Report to the Future Melbourne (Planning) Committee

**Planning Permit Application: TP-2018-774
132-138 Little Bourke Street, Melbourne**

19 March 2019

DELEGATE REPORT

DRAWING : LIGHTING

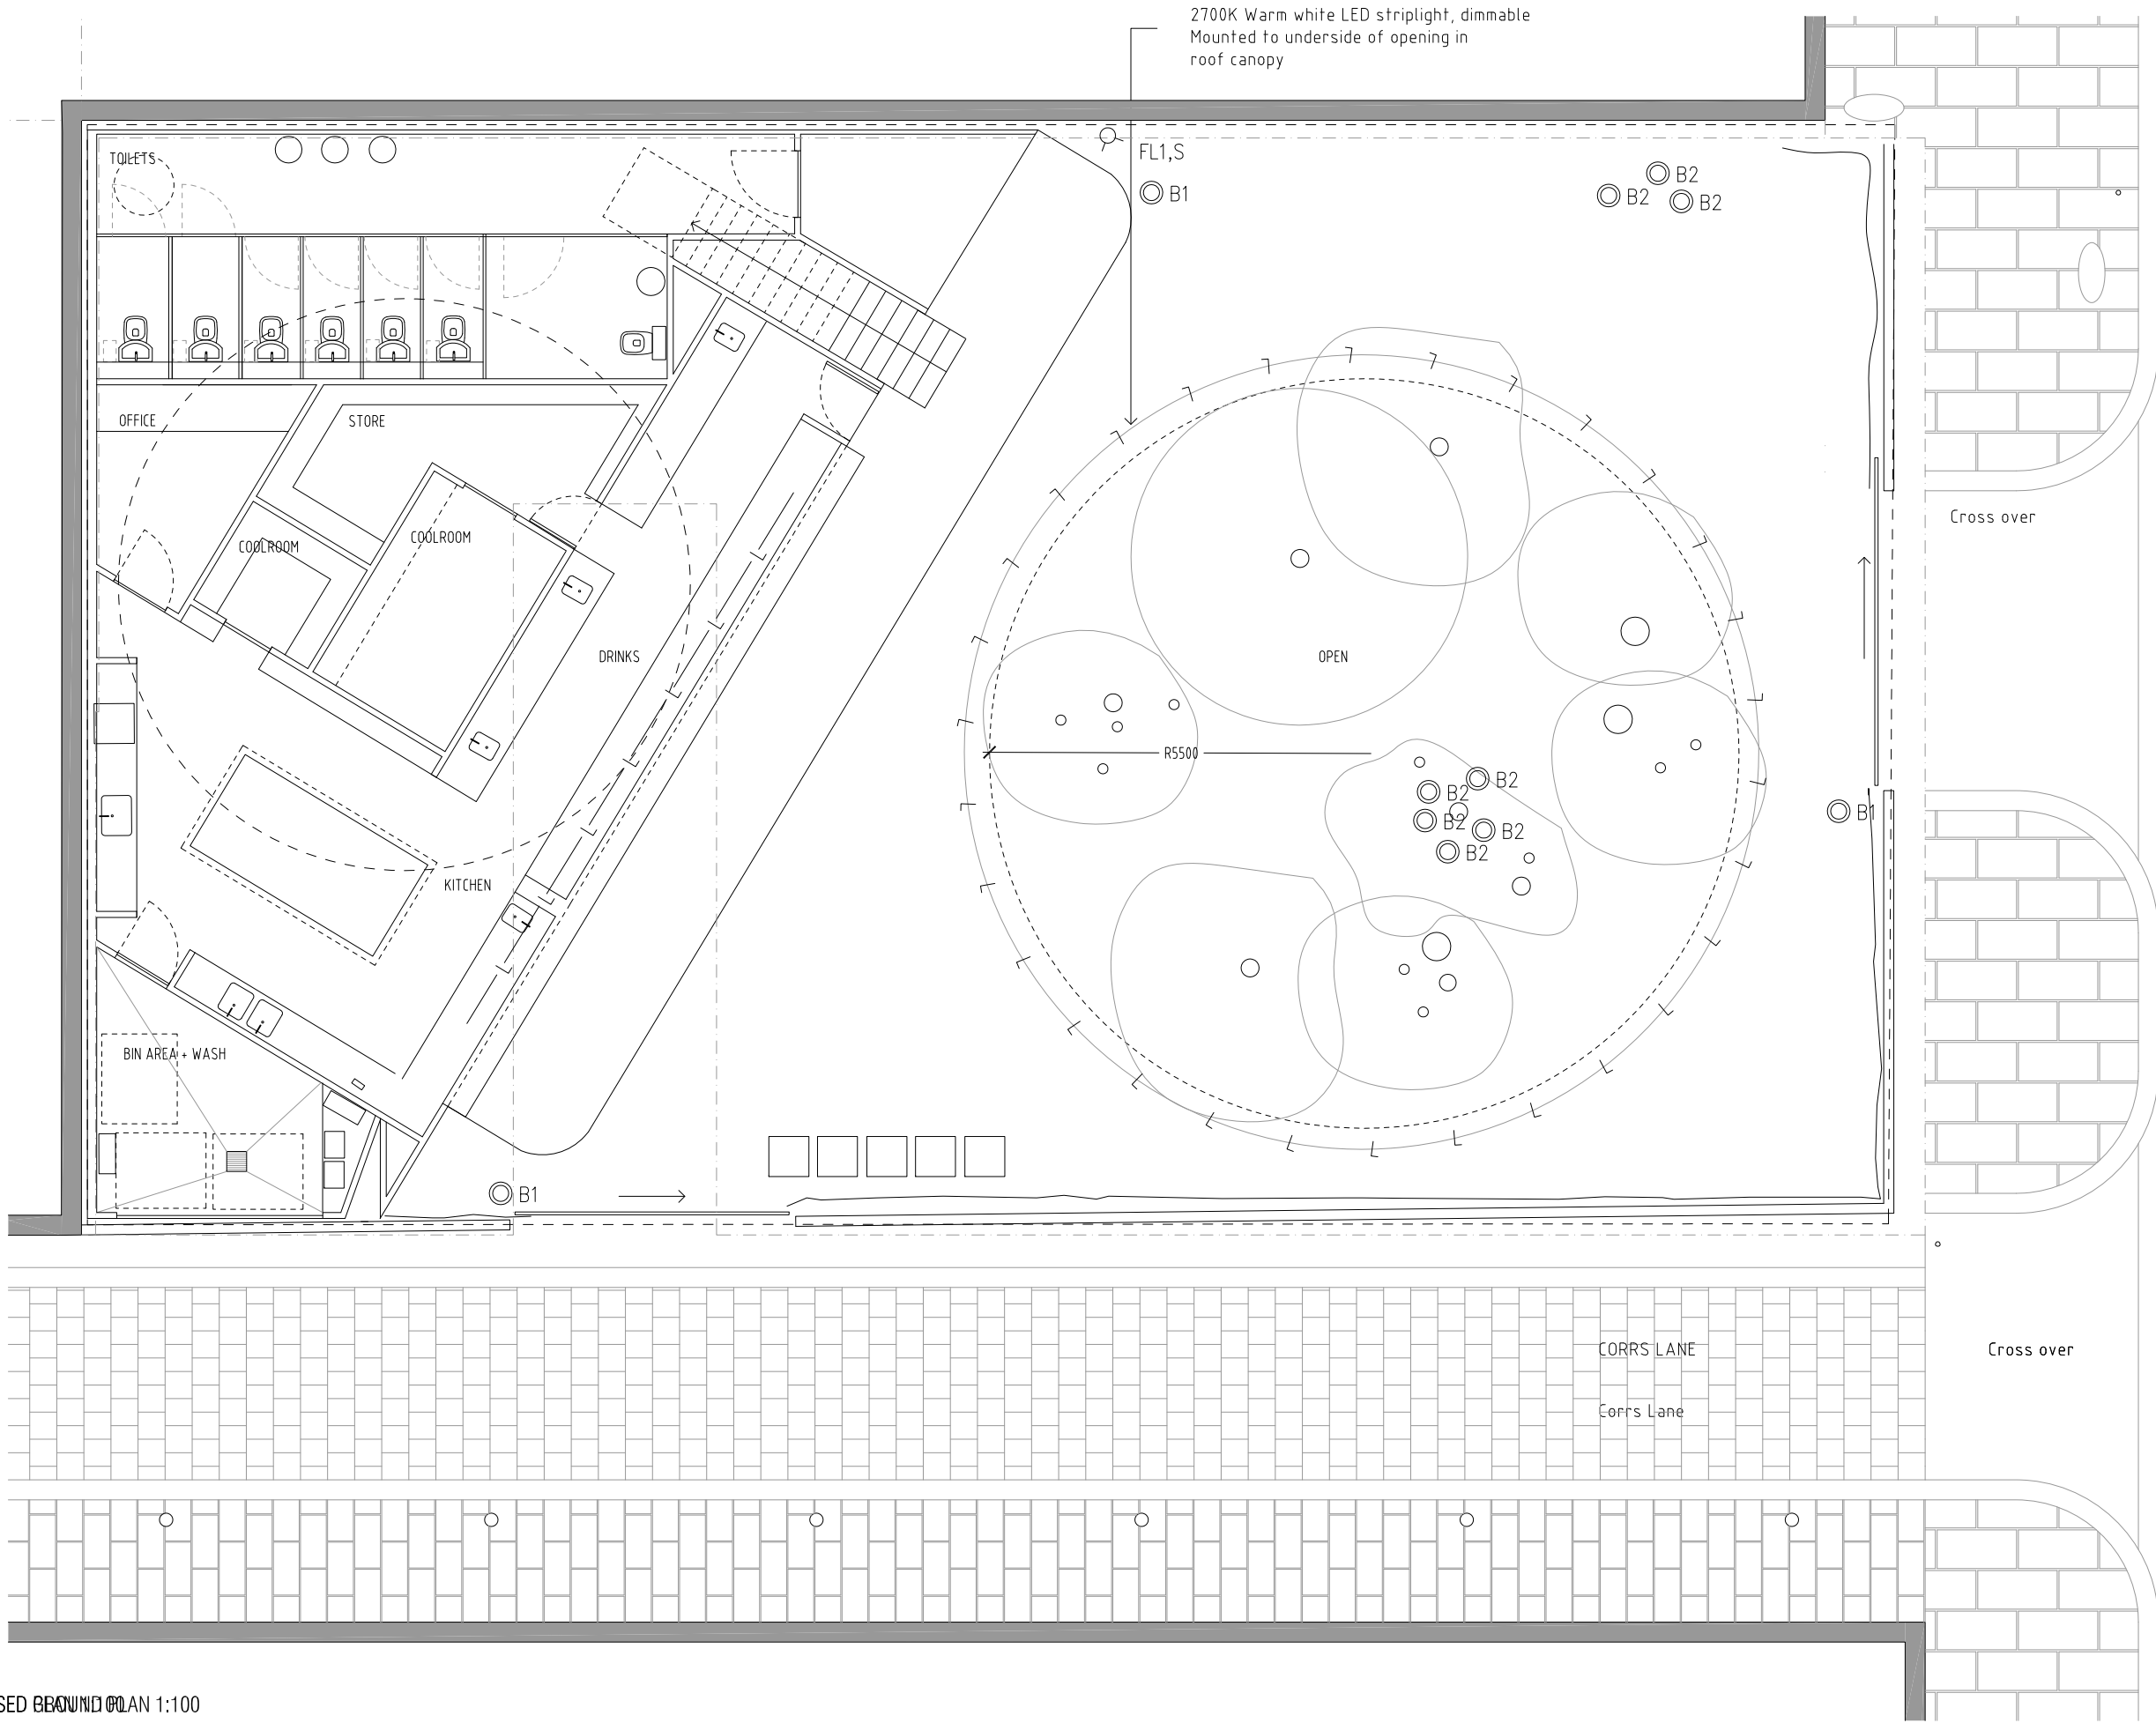
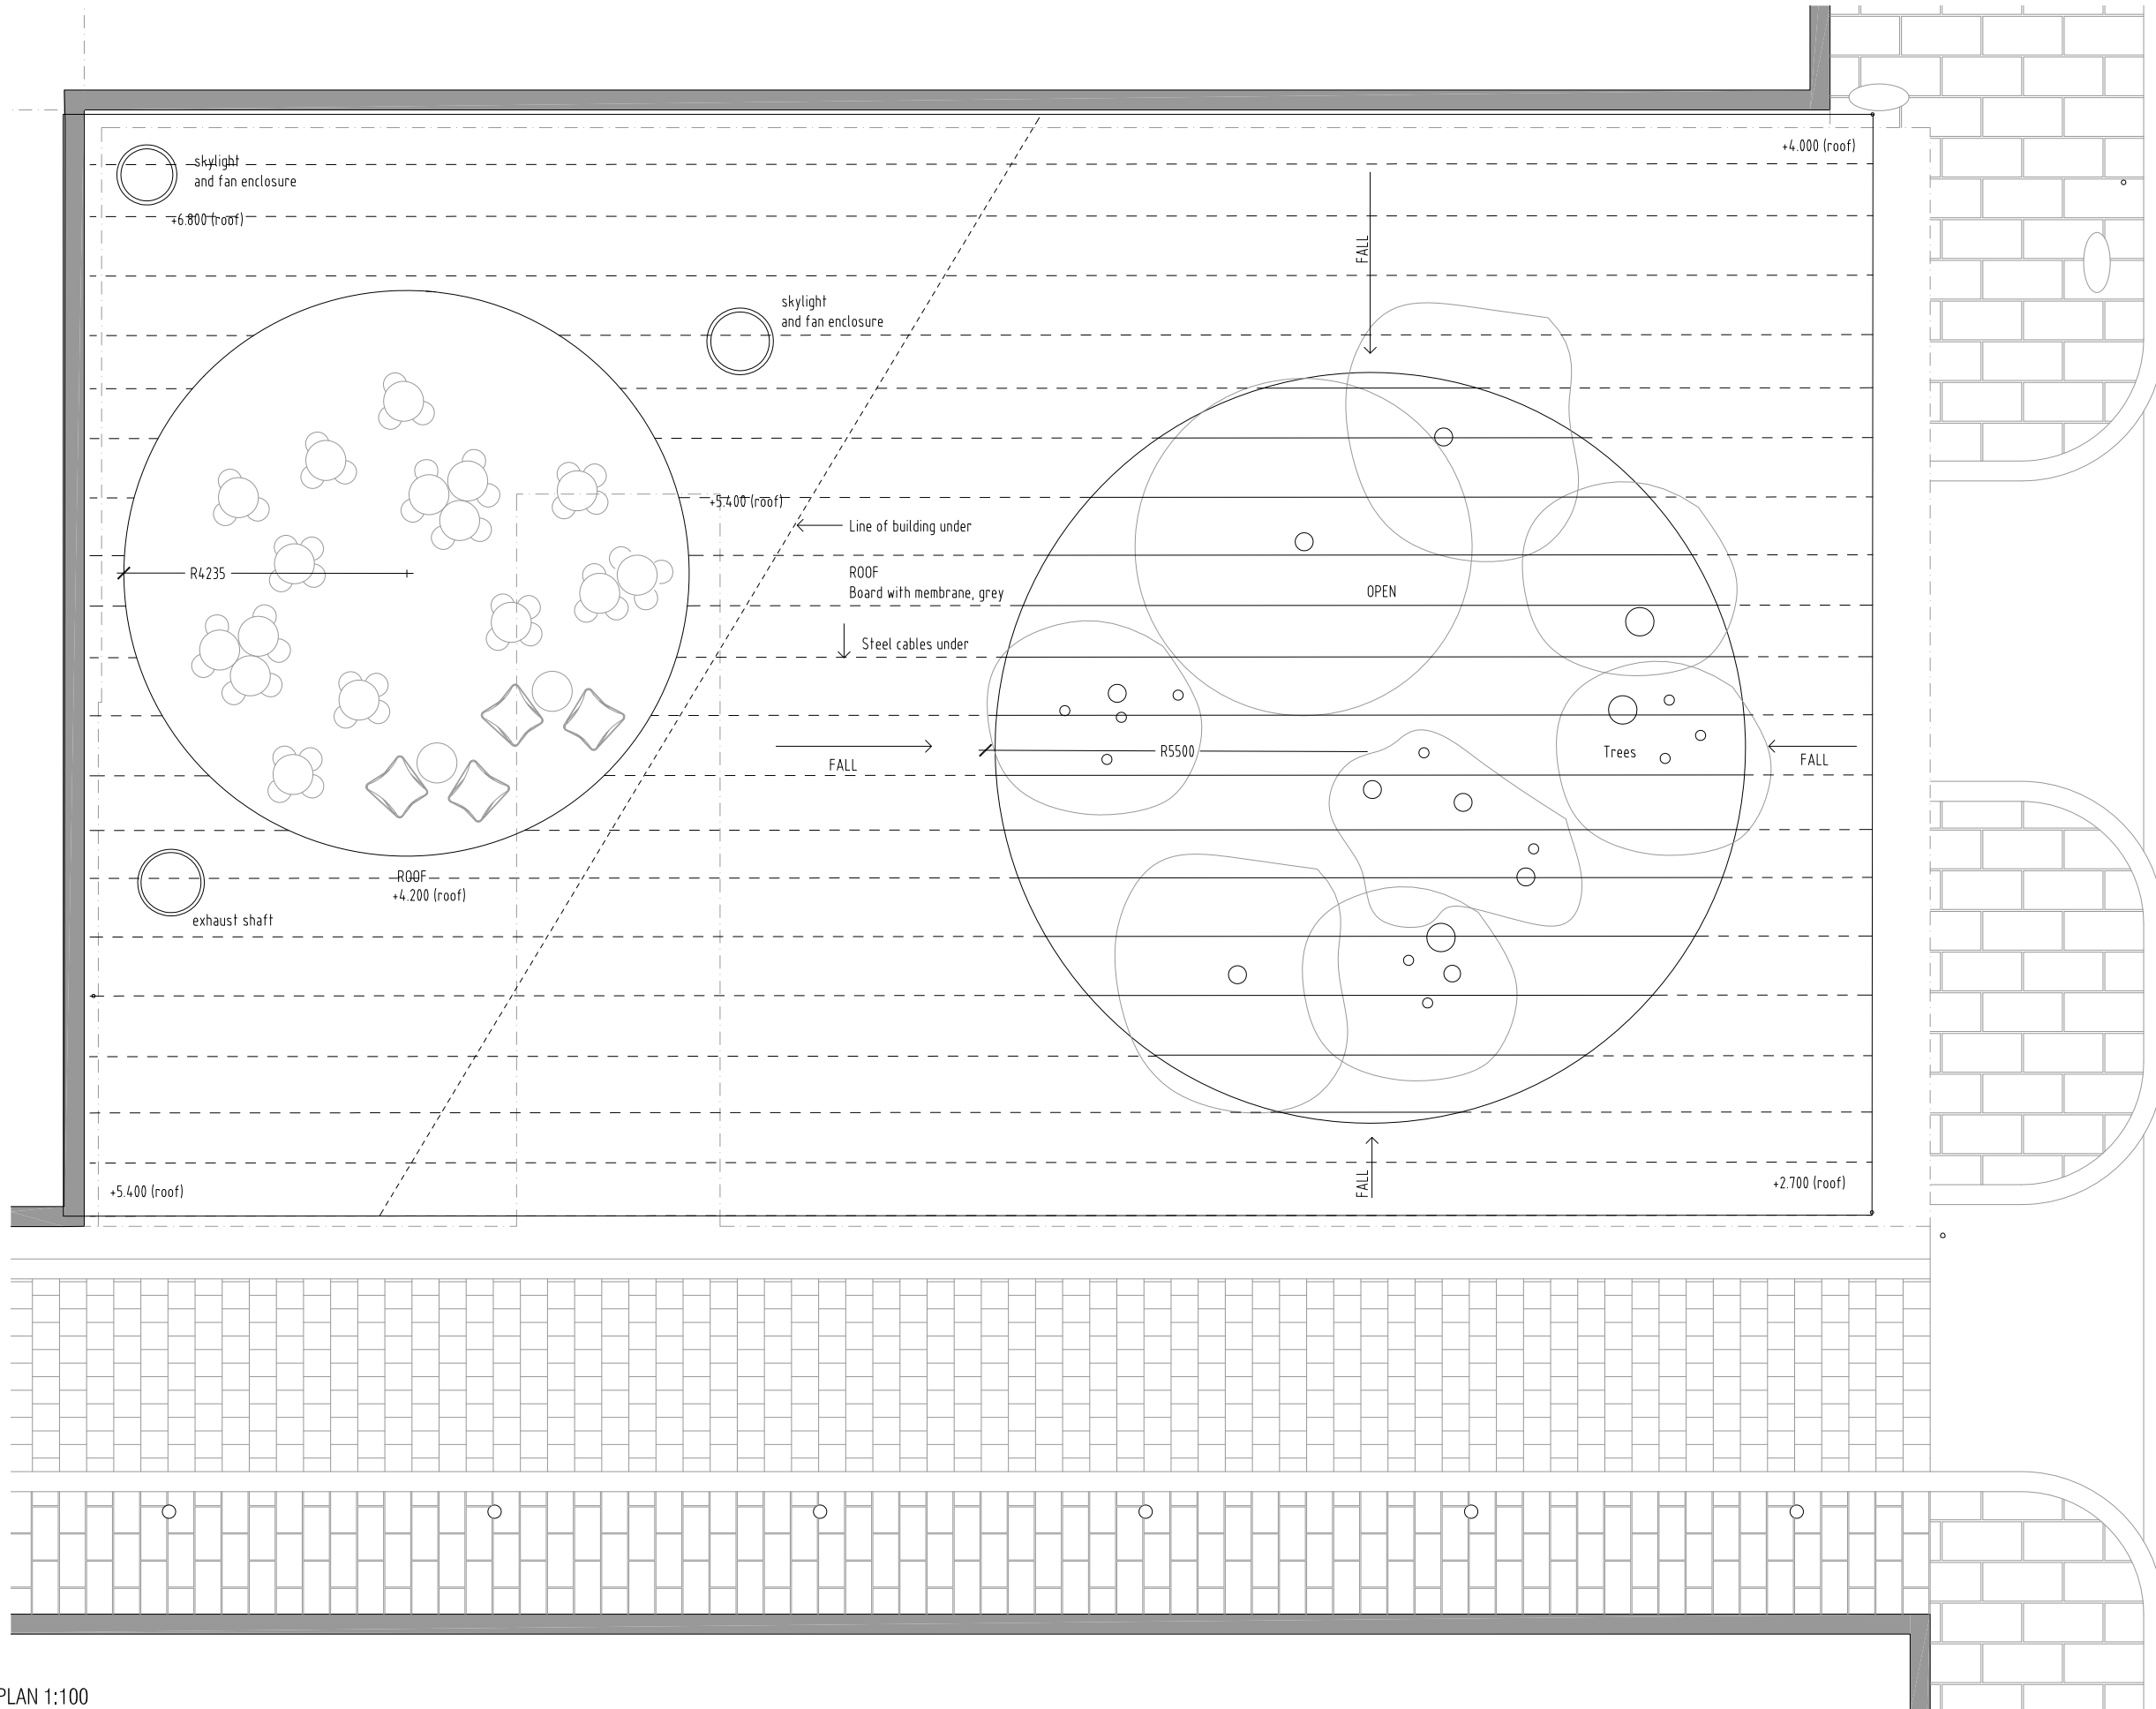
The proposal incorporates lighting. The plans indicate that the lighting is low level and baffled however a condition of permit will require that a lighting strategy plan must be endorsed prior to the development commencing.

3. Prior to the commencement of the development, a lighting plan must be prepared and submitted to the satisfaction of the Responsible Authority. The lighting plan should be generally consistent with the City of Melbourne Lighting Strategy and conform with relevant Australian Standards, and include details of proposed fittings in a schedule on the plan and must be designed, baffled and located to the satisfaction of the Responsible Authority.

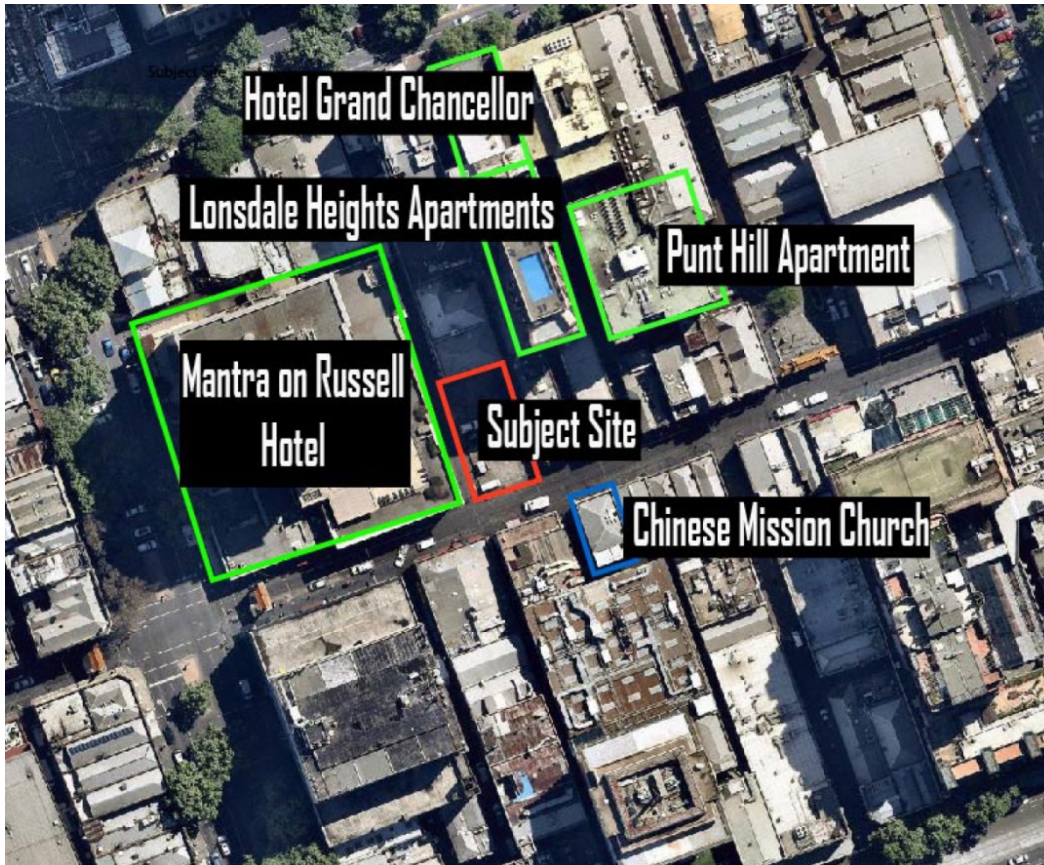
The works include a two storey structure built along the north and part of the eastern boundary which contains the kitchen, drinks area, storerooms, toilets, stairs and utilities at ground level and a roof deck with seating and toilets above. The ground level has seating provided on a crushed rock base with proposed landscaping under a circular roof cut into a canopy which is strung over the site and not attached to adjoining buildings.

The canopy extends over the site with two circles open to the sky. A galvanised cyclone woven wire fence forms the boundary onto Corrs Lane and Little Bourke Street. Landscaping is proposed but further detail will be required.

- a) The mesh fence and canopy structure to be freestanding and not affixed to adjoining buildings.
 - b) Any changes required by the lighting plan (condition 3).

South elevation including signage

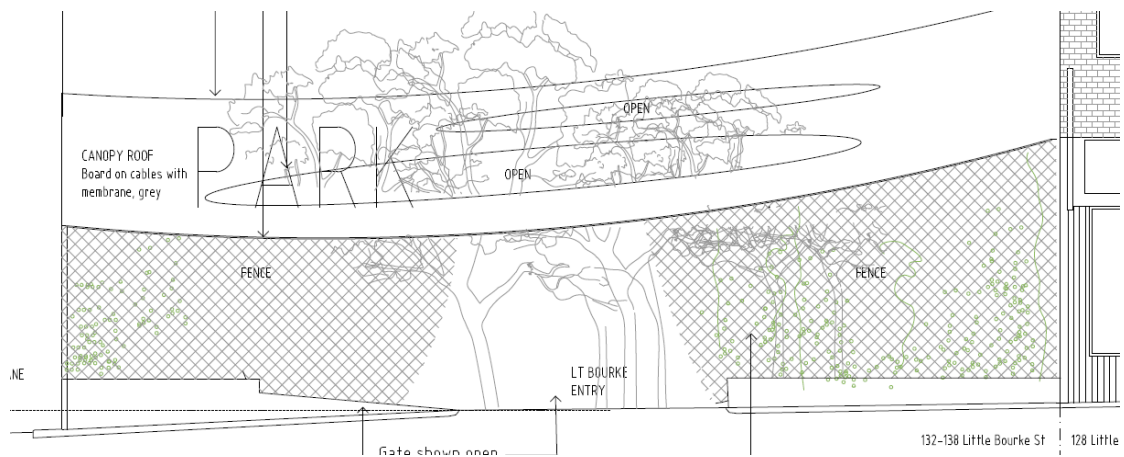
The proposed signage is not in the typical Little Bourke Street traditional Chinese elongated rectangular style, however the restaurant is not Chinese and therefore that form of signage is not appropriate to the use. The proposed signage is set back approximately 2 metres from the street frontages and consists of neon tube letters 1.35 metres high over a length of 3.53 metres.

- The illumination of the sign will not unreasonably impact upon Little Bourke Street as the street is well-lit and most commercial premises display some form of internally-illuminated signage.
- The proposed illuminated neon tube sign is internal to the site and may be partially screened from the street once vegetation has been planted. The

14. The location, size, material of construction, colours, wording and degree of illumination of the sign shown on the endorsed plans must not be altered or modified without the prior written consent of the Responsible Authority.
